WURLITZER SERVICE SLANTS

SUBJECT: Modification of Control Unit wiring to correct Readout Switch circuitry .
COMPLAINT: Phonographs intermittently playing incorrect selections .
CAUSE: High Resistance in Readout Switches resulting in Readout Switch contact contamination .
CORRECTION: To correct above complaint, if apparent, perform the following:

FIGURE 1 - HOLE LAYOUT

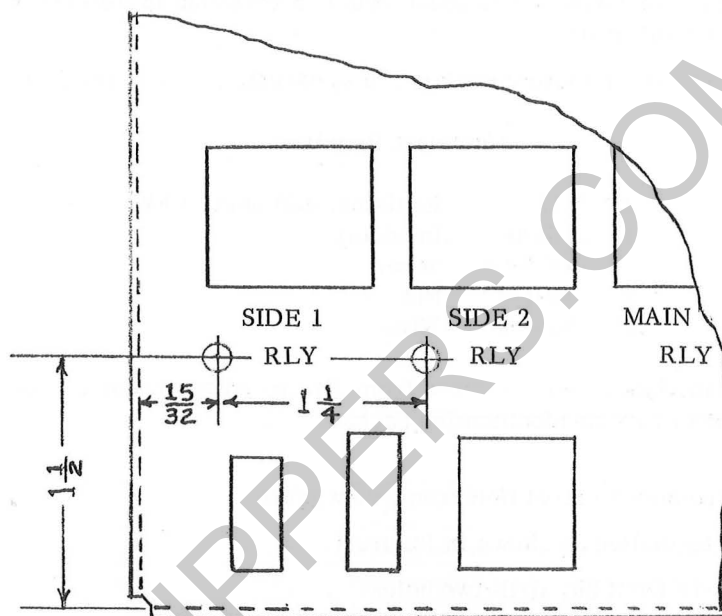
1. Disconnect and remove Control Unit from Phonograph .
2. Layout holes to be drilled as shown in Figure 1 .
3. Using a Number 18 Drill Bit, drill two holes .

FIGURE 2 .

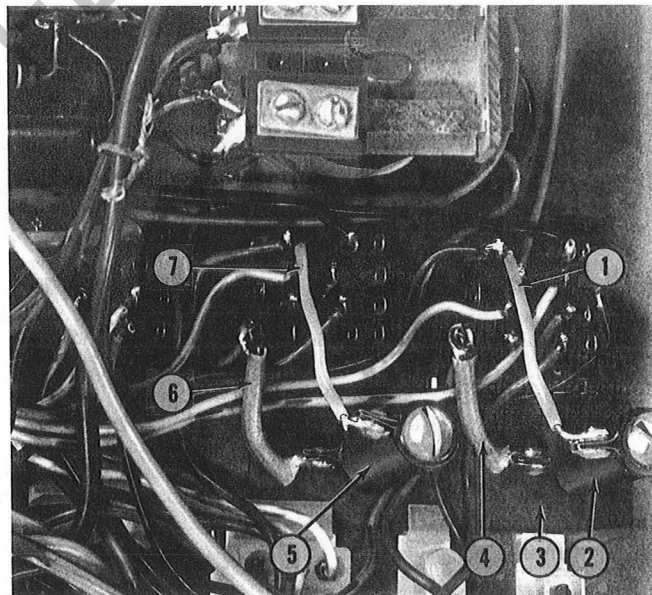
4. Remove burrs from drilled holes .
5. Place Insulator (Item 3, Figure 2), Part No. 137300, in Chassis and Socket Assembly as shown in Figure 2 .
6. Install Screws, Part No. 74850-98, in Resistors, Part No. 77377 .

7. Install Resistors with Screws through Insulator (Item 3, Figure 2) and holes in Chassis and Socket Assembly as shown in Figure 2 .
8. Install Nuts, Part No. 73601-7, on Screws and tighten nuts until snug .

9. Cut Wire, Part No. 75004-9, into four 3" pieces . Strip and tin ends of wires .
10. Connect one 3" piece of wire (Item 1, Figure 2) between top lug of Resistor (Item 2, Figure 2) and Contacts 9 and 13 of SIDE 1 RLY Socket as shown in Figure 2 .

11. Connect one 3" piece of wire (Item 4, Figure 2) between bottom lug of Resistor (Item 2, Figure 2) and Contact 14 of SIDE 1 RLY Socket as shown in Figure 2 .

12. Connect one 3" piece of wire (Item 7, Figure 2) between top lug of Resistor (Item 5, Figure 2) and Contacts 9 and 13 of SIDE 2 RLY as shown in Figure 2 .

13. Connect remaining 3" piece of wire (Item 6, Figure 2) between bottom lug of Resistor (Item 5, Figure 2) and Contact 14 of SIDE 2 RLY as shown in Figure 2 .
